LAND USE COMMITTEE AGENDA

A. Case 2022-06 Gerber Park
PUD Development Plan
Developer: Boulder Holdings, LLC
Engineer: TWM

Staff Report
Gerber Park PUD Development Plan
Land Use Committee – Thursday, January 20, 2022

FRONT ELEVATION

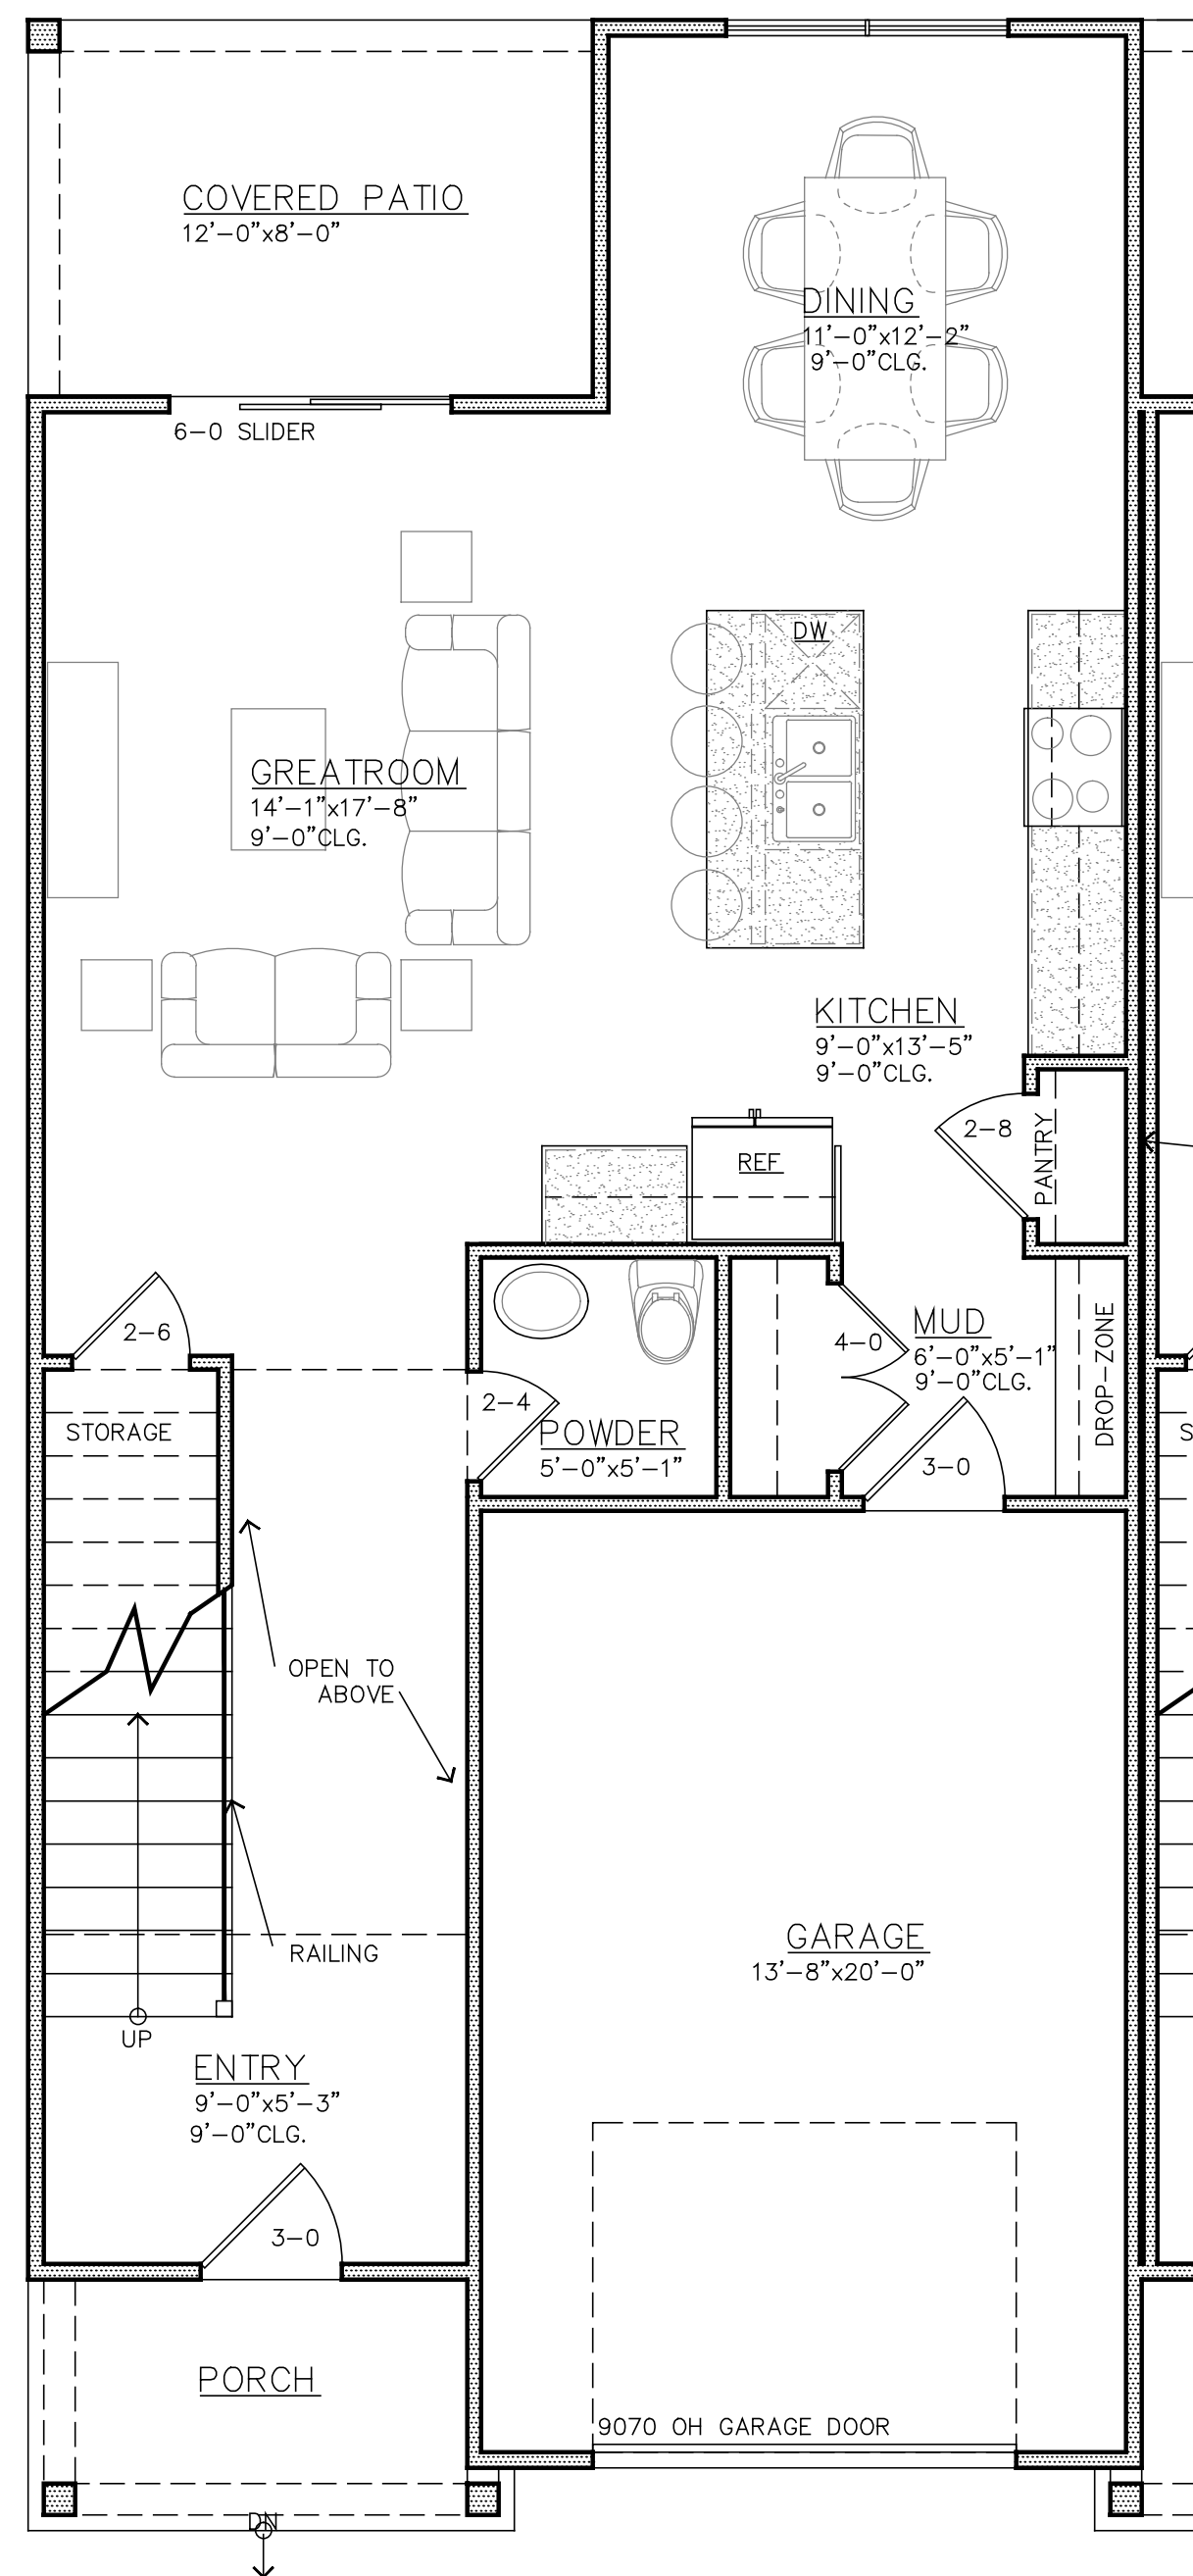
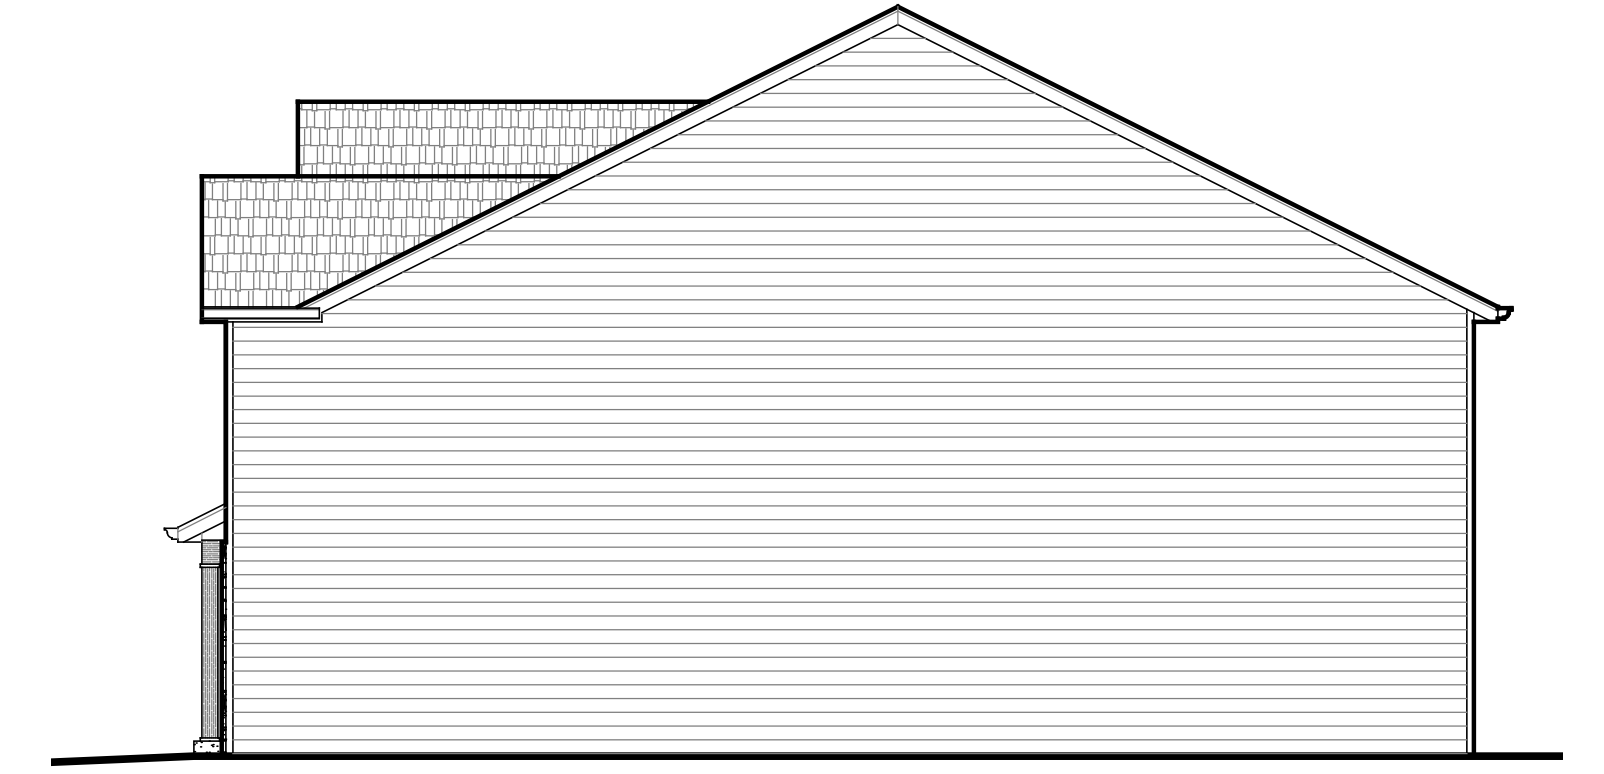
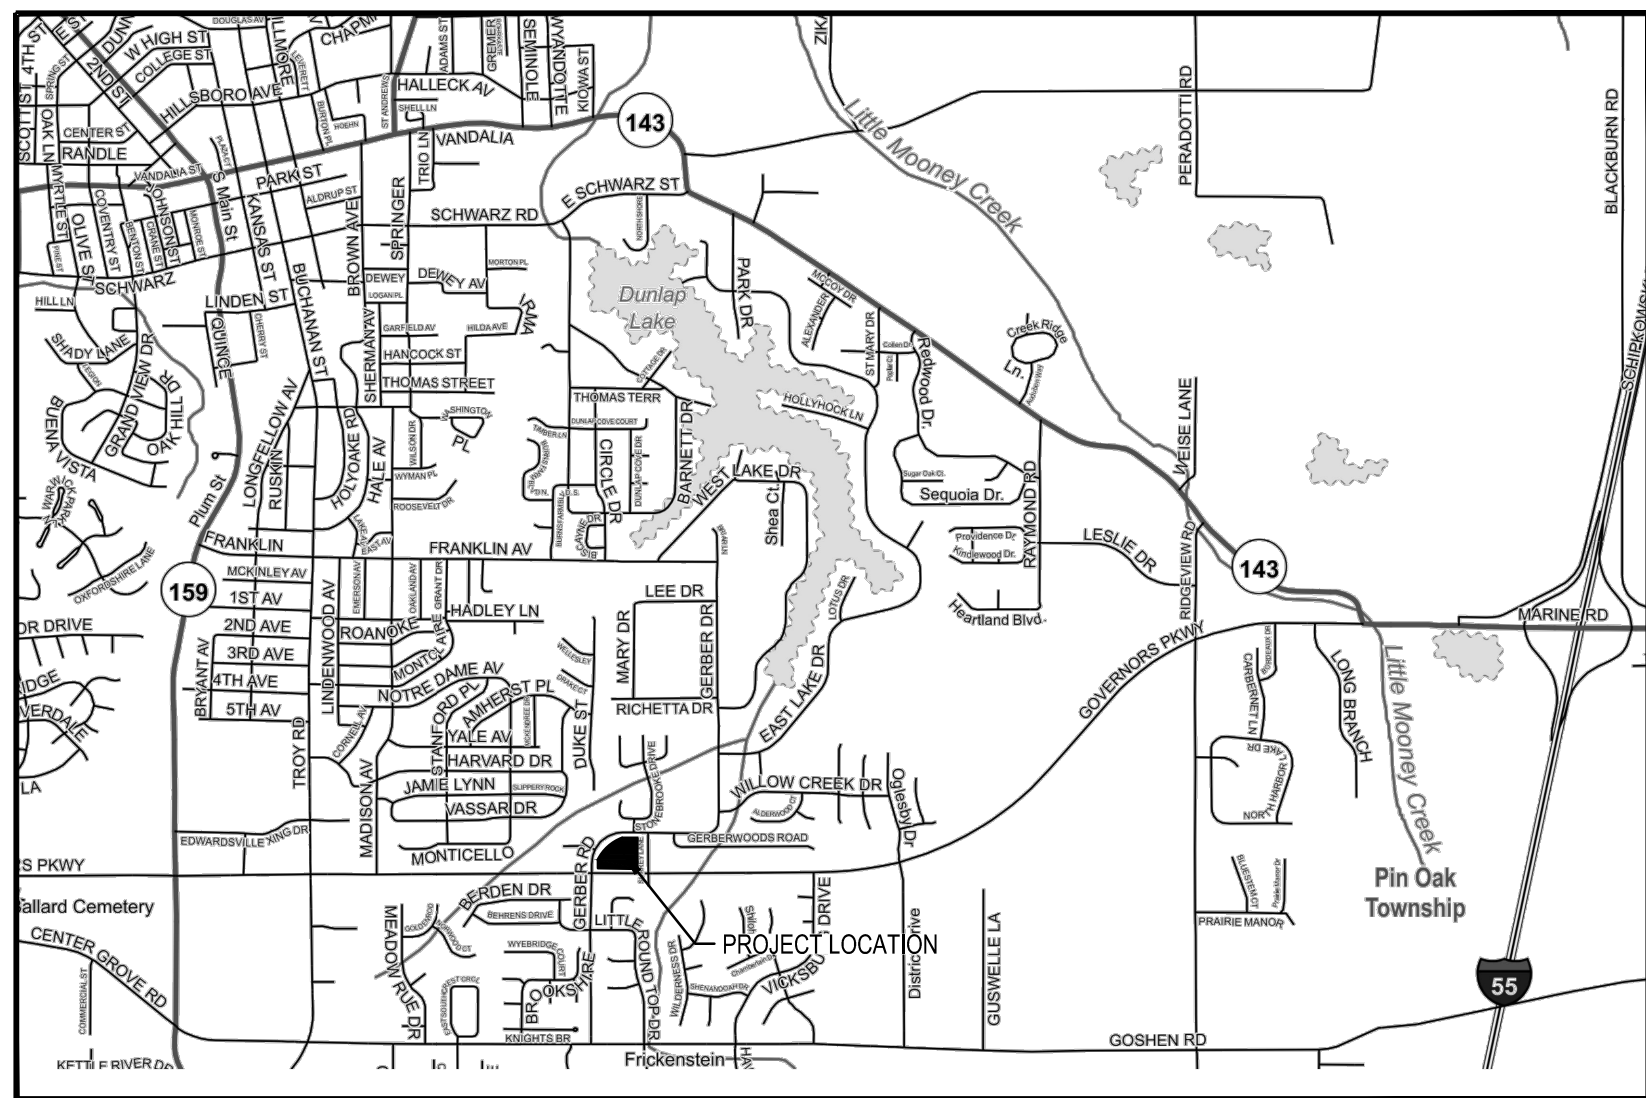
15. The City's Design Guidelines apply to this development. The Design Guidelines for the "R-1" Single-Family District state:

Construct all structures to have a minimum of 35 percent of the exterior walls constructed of brick, brick veneer, stone, masonry, masonry veneer, stucco, and/or architectural precast concrete from the ground level (the building foundation) to the building's eaves (excluding gables, dormers, openings for windows and doors, and trim). These materials shall be prioritized on the sides of the homes which abut right-of-way and trails.

At least 35 percent of the front of the house must also be comprised of these materials. The "front of the house" is comprised of all exterior surface areas between the outer most, forward corners on each side of the structure

SITE PLAN

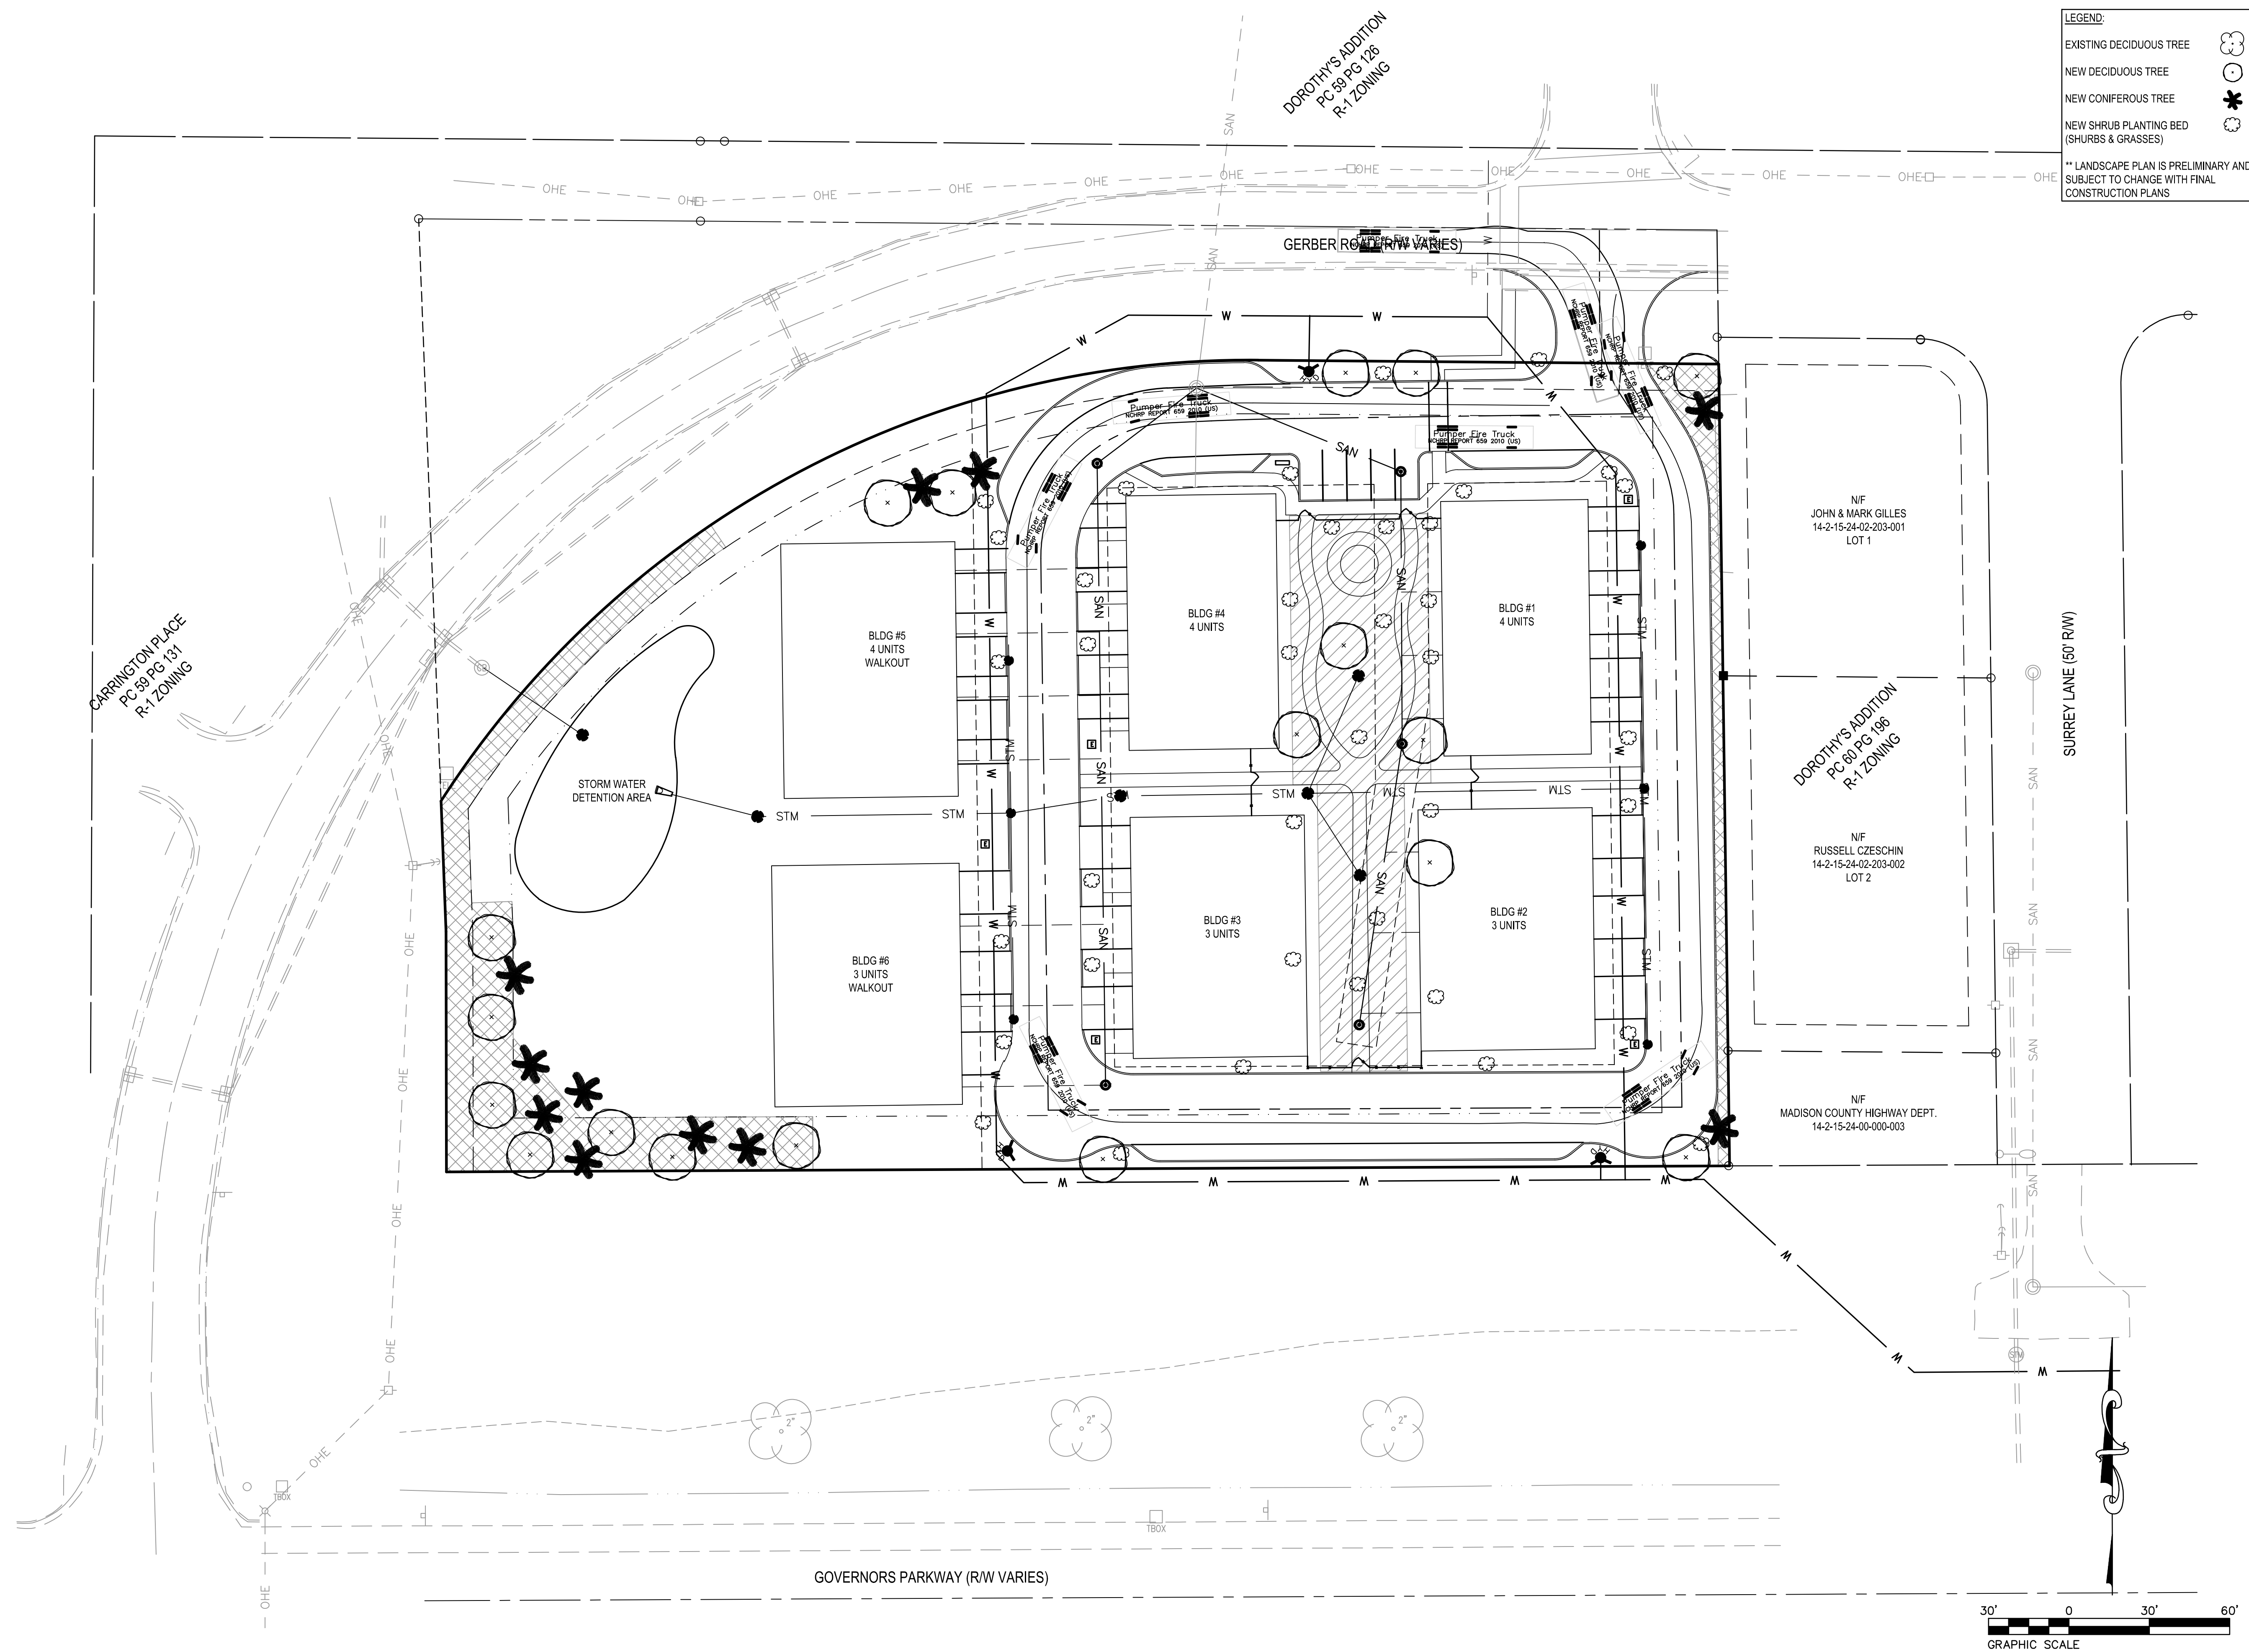
1. Indicate that Boulder Holdings, LLC is the owner & developer
2. Indicate ROW acreage
3. Indicate POC and POB on page 2 of the PUD Development Plan
4. Site should be relabeled at page 3.

5. Building footprints scale to 65' x 90'. Please add these dimensions to the site plan.
6. Add number of off-street parking spots provided in parking trays/areas

7. Sanitary Sewer needs to be shown clearly on site plan
8. Setback layer needs to be brought to the front so that they are clearly visible.
9. Private roadway scales to 26 feet of pavement, but please indicate this on plans.

10. Please provide Covenants and Restrictions
11. Need ECOCAT, IHPA, and NFIP FEMA flood map letters.
12. Remove all references to the grain silo accessory structure on the plans.

13. Indicate the proposed location of signage for the PUD Development will be located on the site plan.
14. Add in the narrative a request for a variance to allow for the drive aisle location to be less than the required 5 feet from the eastern property line.
